14201 Southington Road

For variances to replace the parking lot, relocate and expand the playground, and enclose the dumpsters and generator.

STAFF REPORT

TREE PRESERVATION PLAN

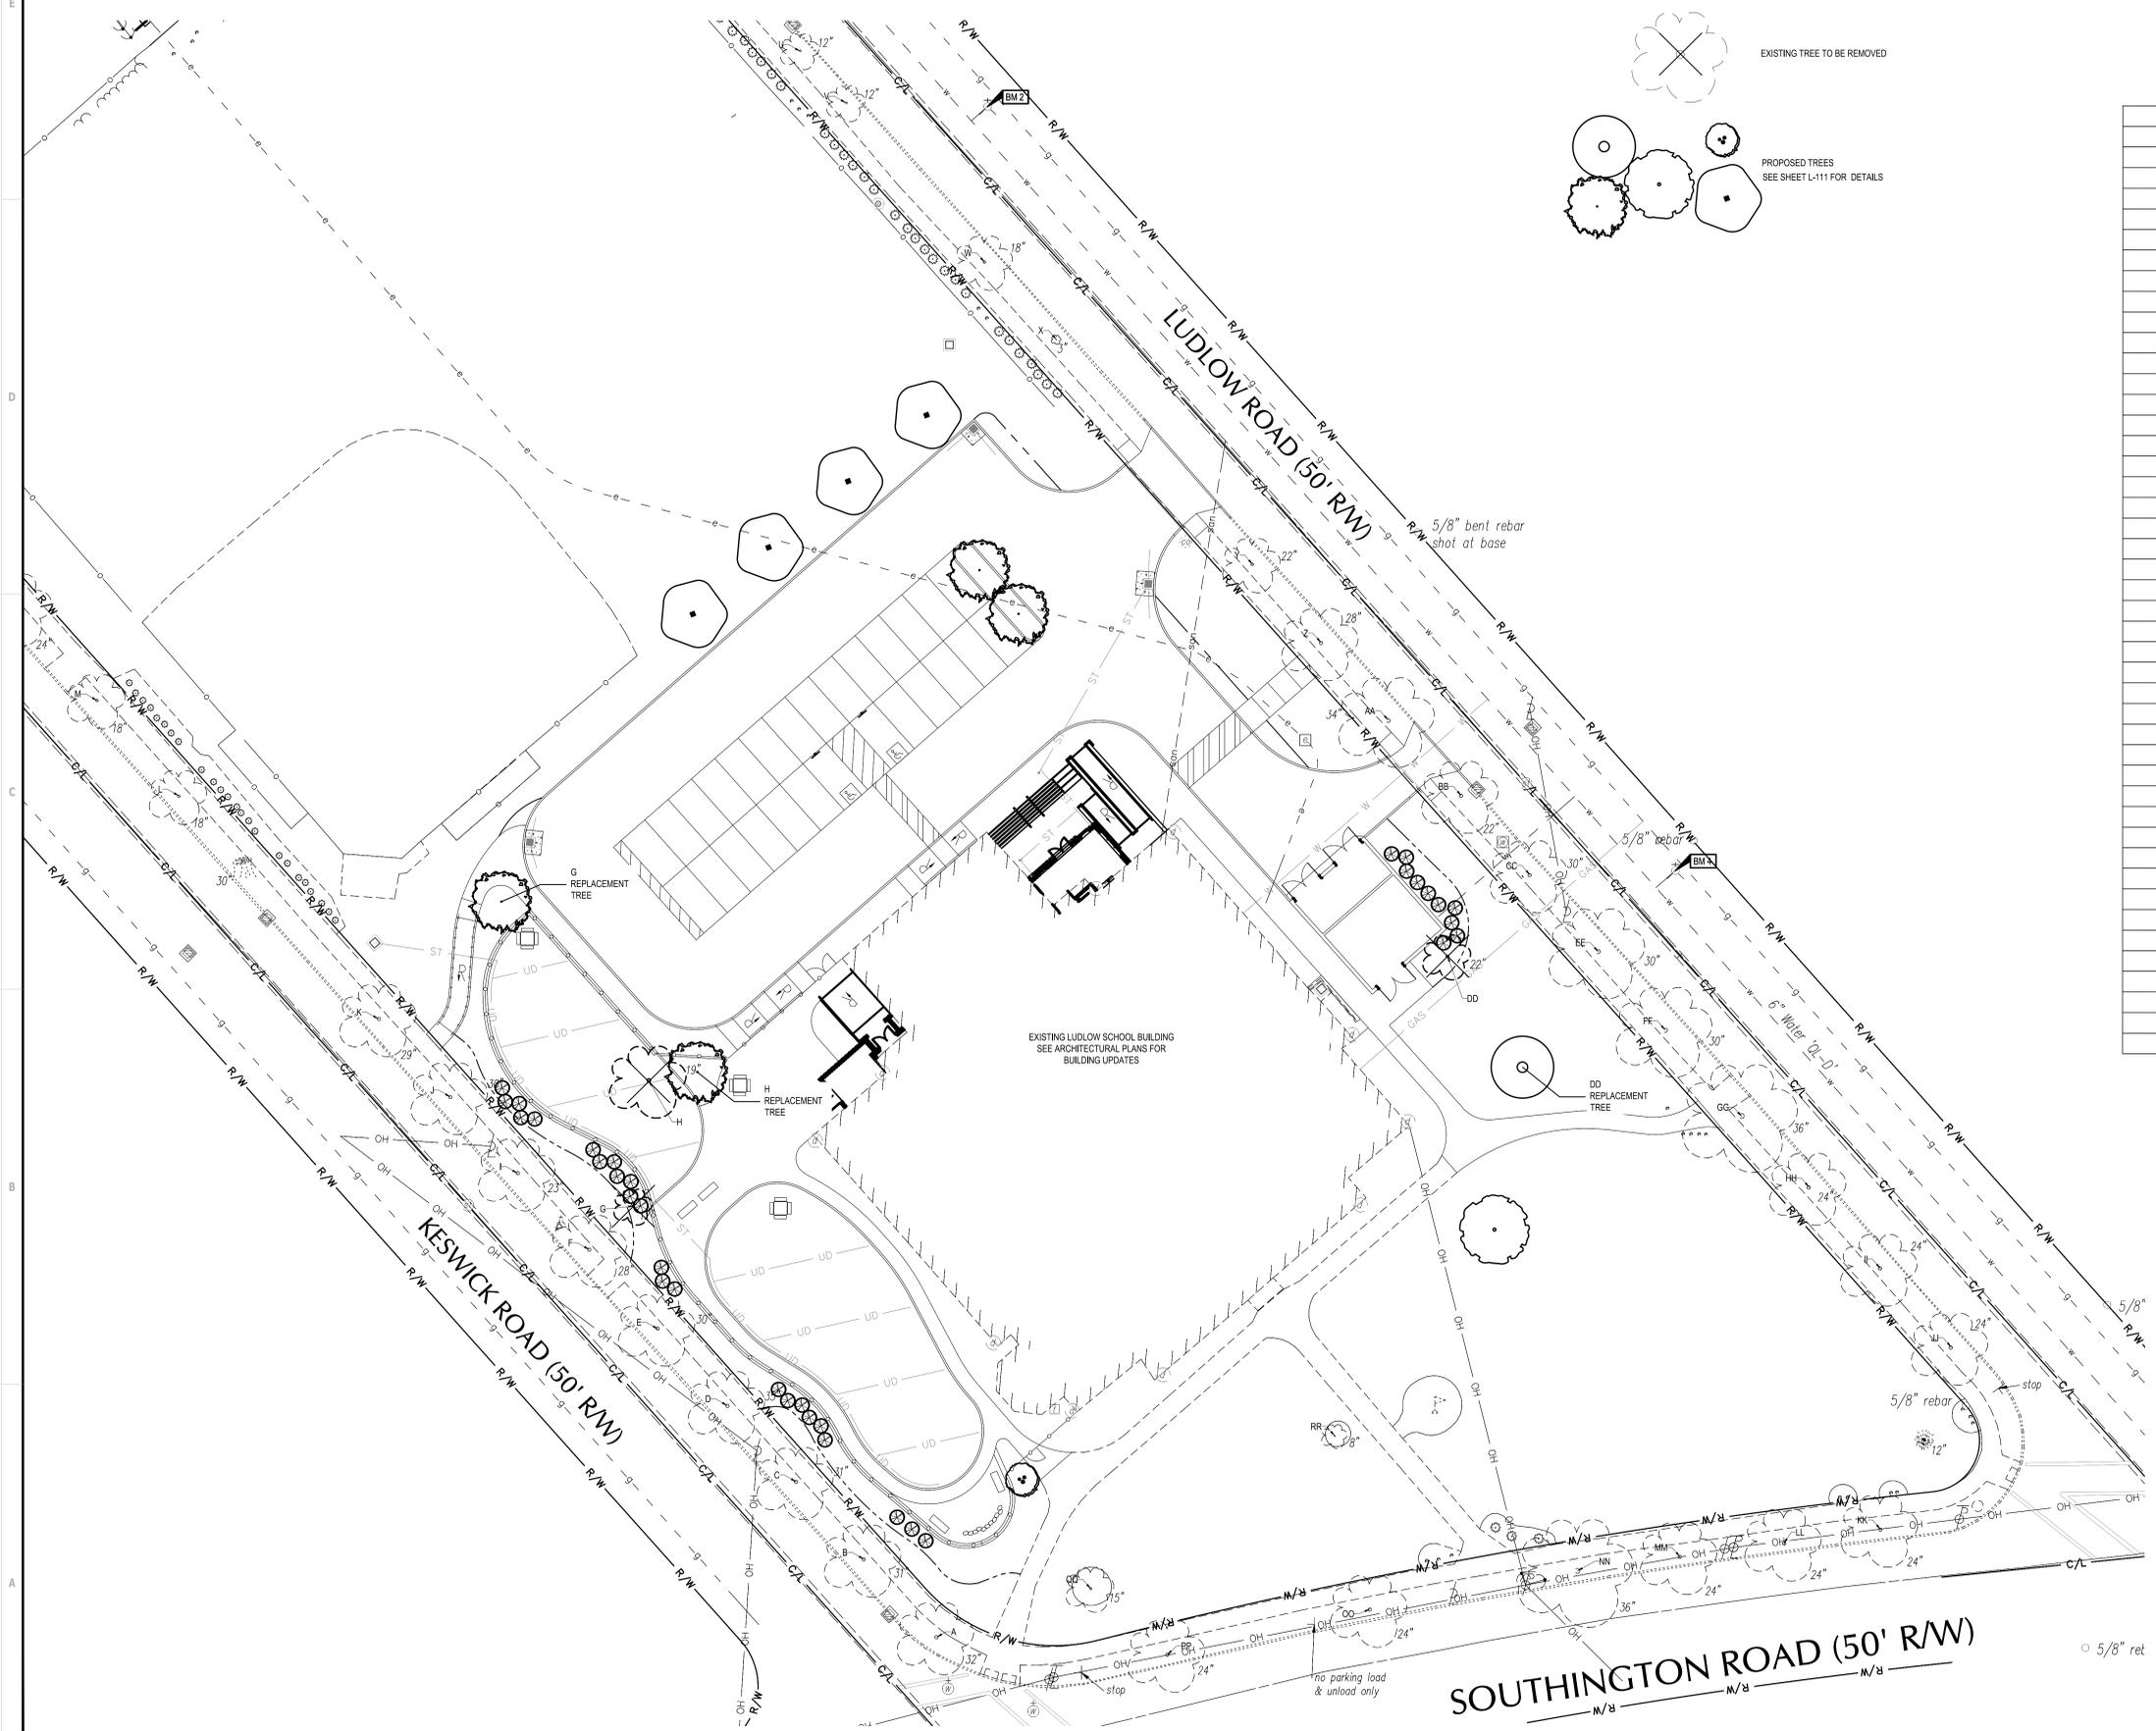
4. A tree preservation plan has been submitted that replaces the several one site trees that are proposed to be removed. That plan does not adequately show tree preservation fencing, practices or other techniques to save the mature street trees from construction impact.

10. Questions and corrections have been raised of the street tree sizes and the appropriate critical root zone calculation.
11. The brick wall around the dumpster and generator is 8-feet tall in order to hide an estimated 9 foot tall generator.

- Applicant proposes that it is acceptable to damage up to 25% of tree root areas. Reviewing with an ISA-certified arborist, they indicated that while guidelines vary by tree species, location, age and other factors, typical practice is to limit impacts to no more than 15% of the root mass.
- From the same ISA-certified arborist *"We've seen construction damage take up to 10 years to show up in mature trees and rapid decline follows. Construction damage can also occur without subsurface damage. Something as simple as staging equipment an/or job material under a tree can cause rapid decline a handful of years down the line depending on the species."*

- More thorough assessment of existing trees and their condition
- A conservative tree protection plan, assessing the specific conditions related to each tree, based on less risky protection standards
- Re-working of grading and hardscape locations to avoid threats to mature street trees.
- Study alternative grading and or soil/drainage treatments as strategies to reduce impacts on work within root zones
- Develop robust tree protection measures during construction including semi-permanent protective fencing that cannot be easily moved, staging of construction trailers and equipment, etc. so there is no unnecessary work, compaction, or other damage.

LANDSCAPE PLAN

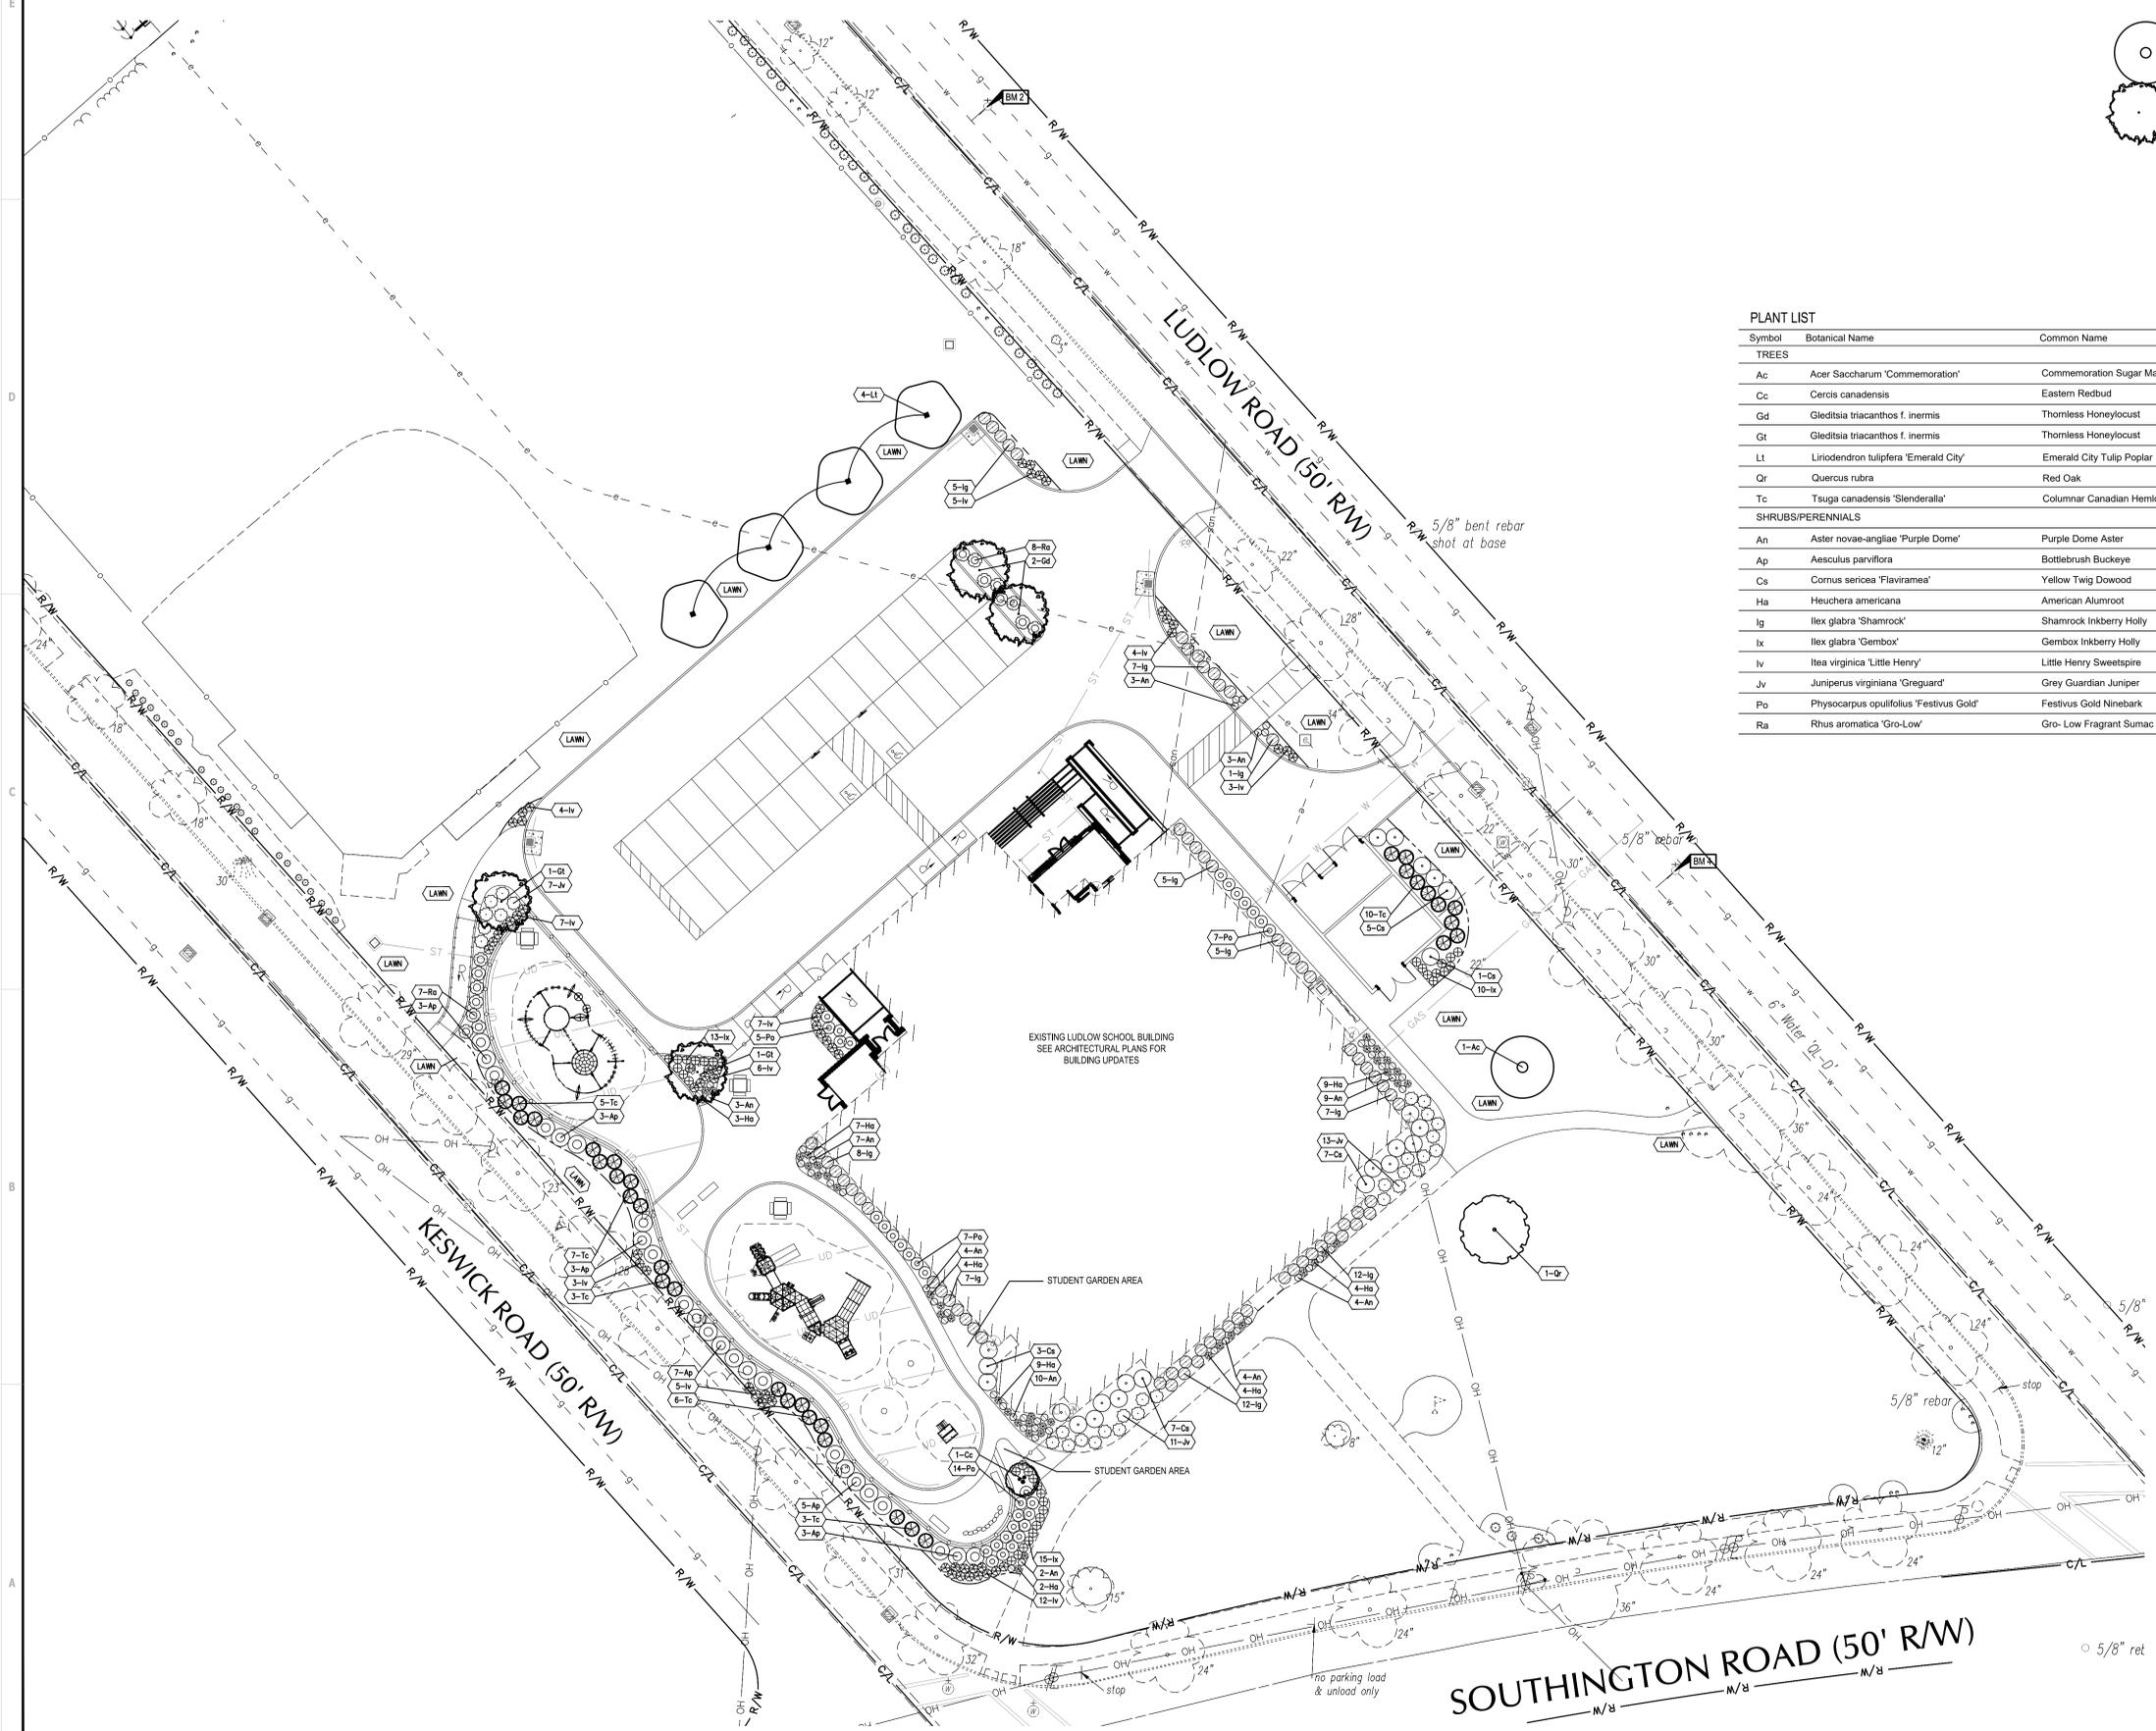
6. The holly shrubs proposed in the plan need to be evaluated for potential berry production as the fruits can be harmful if ingested.
7. Site plan review by the City Planning Commission is required for new buildings or additions of 2,500 sq ft or more. The proposed entry additions are less than 1,000 sq ft combined so site plan review is reviewed by the zoning administrator.

The landscape design isn't yet in tune with how our Shaker community tends to use these facilities. Typically parents' lawn chairs get arrayed along the edge of the parking lot. It's nice that some new trees have been added, which is a great investment in the future shade and usability of this area. However, the parking lot is cut off from the field, permeability in that shrub edge on the west side of the paving will make this more usable. The choice of holly with sharp corners on leaves makes that edge particularly unwelcoming.
